DEFENSE NUCLEAR FACILITIES SAFETY BOARD

Staff Issue Report

SUBJECT: Safe Storage of Sodium Fluoride Traps, Oak Ridge National Laboratory

Figure 1: Pressure in the two monitored NaF/UF₆ traps, and temperature in Bldg 3019.

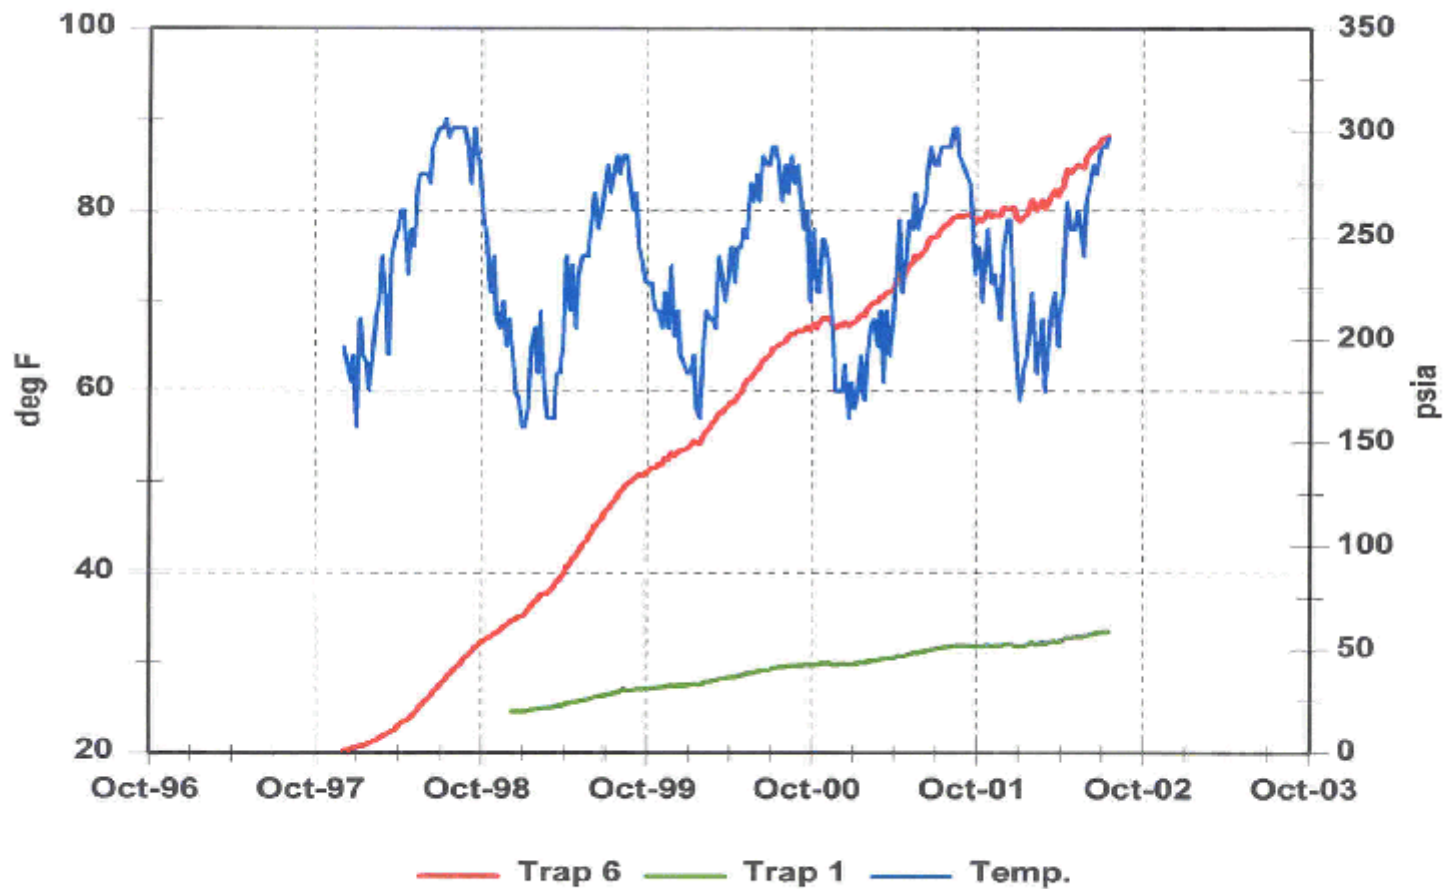
Radiolysis in NaF Traps and Pressure Monitoring. The internal pressure of the traps is increasing because of radiolysis of the NaF-UF₆ compound, which evolves fluorine gas. ORNL monitors the pressure in two traps (traps #1 and #6) stored in Cell 1 of Building 3019A. Figure 1 (attached) presents pressure data provided to the Board's staff by ORNL. The figure shows that the pressure in trap #6 is approaching 300 psig and is continuing to increase. Trap #1 contains considerably less material and has generated less pressure.

The pressure instrument is calibrated for pressures up to 250 psig. Therefore, ORNL is now estimating the pressure for trap #6 based on extrapolation of the calibration data, contrary to industry standards for calibration. Hence, uncertainty exists in the pressure measurements, and this uncertainty will increase as the pressure continues to rise above the calibrated range of the instrument. Furthermore, trap #6 is not believed to be the worst-case trap; thus higher pressures are expected to exist eventually in nine traps stored in the Building 3019A tube vaults. At this time, only one other trap is calculated to have a higher pressure than trap #6.
